# Access Compliance Report

## Public Rights-of-Way

Intersection ID: 48365	Main Street: SULKY_PLOUGH_RD	Cross Street: RED_COW_RD	Location: NE
ADA ID: 71666290FC77	Ramp Type: PerpDiag	Initial Pass/Fail: Fail	Overall Compliance: No
Severity Score: 13.75			
Codes/Mitigation Info/Possible Solution		Field Measurements/Component Compliance

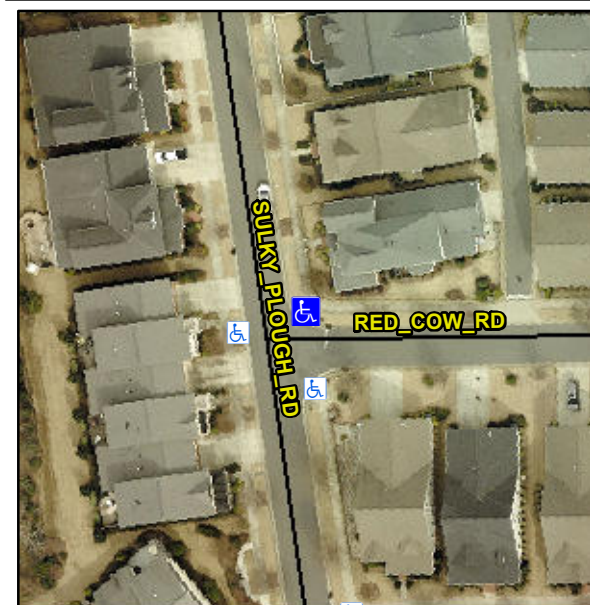
**Not Found, R304.2.2, R304.5.3**

Compliance	Description	Data	Compliance	Description	Data
N/A	Ramp Length (in)	72.0	No	Ramp Slope (%)	9.1
Yes	Ramp Width (in)	48.0	No	Ramp XSlope (%)	2.5
N/A	Flare Type LT	N/A	N/A	Flare Type RT	N/A
N/A	Flare Slope LT (%)	N/A	N/A	Flare Slope RT (%)	N/A
N/A	Flare Traversable LT?	N/A	N/A	Flare Traversable RT?	N/A
N/A	Landing Length (in)	N/A	N/A	DWS Provided?	N/A
N/A	Landing Width (in)	N/A	N/A	DWS Contrast?	N/A
N/A	Landing Slope (%)	N/A	N/A	DWS Length (in)	N/A
N/A	Landing X Slope (%)	N/A	N/A	DWS Full Width?	N/A
N/A	Landing Curb? (Y/N)	N/A	N/A	DWS Offset (in)	N/A
N/A	Shared Landing?	N/A			
N/A	Gutter Ponding?	N/A	N/A	Gutter Slope (%)	N/A
N/A	Gutter Lip Ht (in)	N/A	N/A	Gutter X Slope (%)	N/A
N/A	Painted X Walk1?	No	N/A	Painted X Walk2?	No
	X Walk 1 Direction	To W		X Walk 2 Direction	To S
N/A	X Walk 1 Width (in)	N/A	N/A	X Walk 2 Width (in)	N/A
	X Walk 1 Slope (%)	3.9		X Walk 2 Slope (%)	0.0
	X Walk 1 X Slope (%)	1.6		X Walk 2 X Slope (%)	1.1

**Remove & Replace Curb Ramp With Two New Directional Ramps or Equivalent.**
